Access Compliance Report

Public Rights-of-Way

(Curb Ramps)

Intersection ID: N/A	Main Street: TRAILMOOR_RD	Cross Street: BRECKFIELD_CT	Location: SW
ADA ID: 4107D7A38443	Ramp Type: BlendTrans1	Initial Pass/Fail: Fail	Overall Compliance: No
Severity Score: 10			
Codes/Mitigation Info/Possible Solution		Field Measurements/Component Compliance

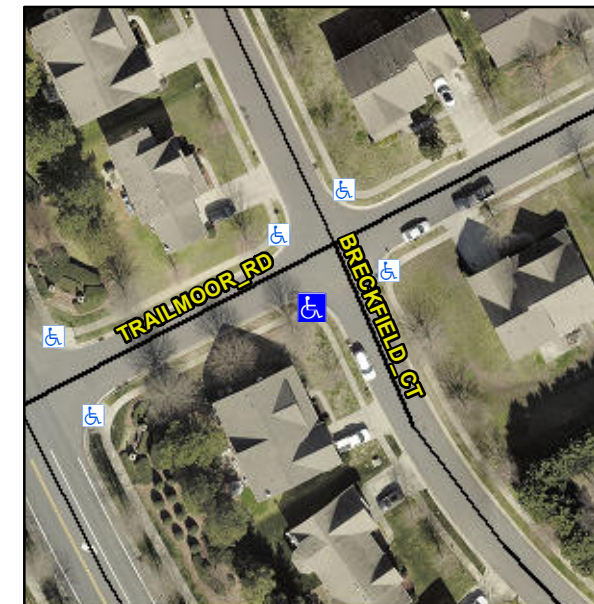
R304.5.1, R304.5.3

Compliance	Description	Data	Compliance	Description	Data
N/A	Ramp Length (in)	45.0	Yes	BlendTrans Slope (%)	4.8
No	Ramp Width (in)	46.0	No	BlendTrans XSlope (%)	3.5
N/A	Flare Type LT	N/A	N/A	Flare Type RT	N/A
N/A	Flare Slope LT (%)	N/A	N/A	Flare Slope RT (%)	N/A
N/A	Flare Traversable LT?	N/A	N/A	Flare Traversable RT?	N/A
N/A	Landing Length (in)	N/A	N/A	DWS Provided?	N/A
N/A	Landing Width (in)	N/A	N/A	DWS Contrast?	N/A
N/A	Landing Slope (%)	N/A	N/A	DWS Length (in)	N/A
N/A	Landing X Slope (%)	N/A	N/A	DWS Full Width?	N/A
N/A	Landing Curb? (Y/N)	N/A	N/A	DWS Offset (in)	N/A
N/A	Shared Landing?	N/A			
N/A	Gutter Ponding?	N/A	N/A	Gutter Slope (%)	N/A
N/A	Gutter Lip Ht (in)	N/A	N/A	Gutter X Slope (%)	N/A
N/A	Painted X Walk1?	No	N/A	Painted X Walk2?	No
	X Walk 1 Direction	To NE		X Walk 2 Direction	To NW
	X Walk 1 Width (in)	N/A		X Walk 2 Width (in)	N/A
	X Walk 1 Slope (%)	0.4		X Walk 2 Slope (%)	1.2
	X Walk 1 X Slope (%)	3.9		X Walk 2 X Slope (%)	1.6

Remove & Replace Curb Ramp With Two New Directional Ramps or Equivalent.
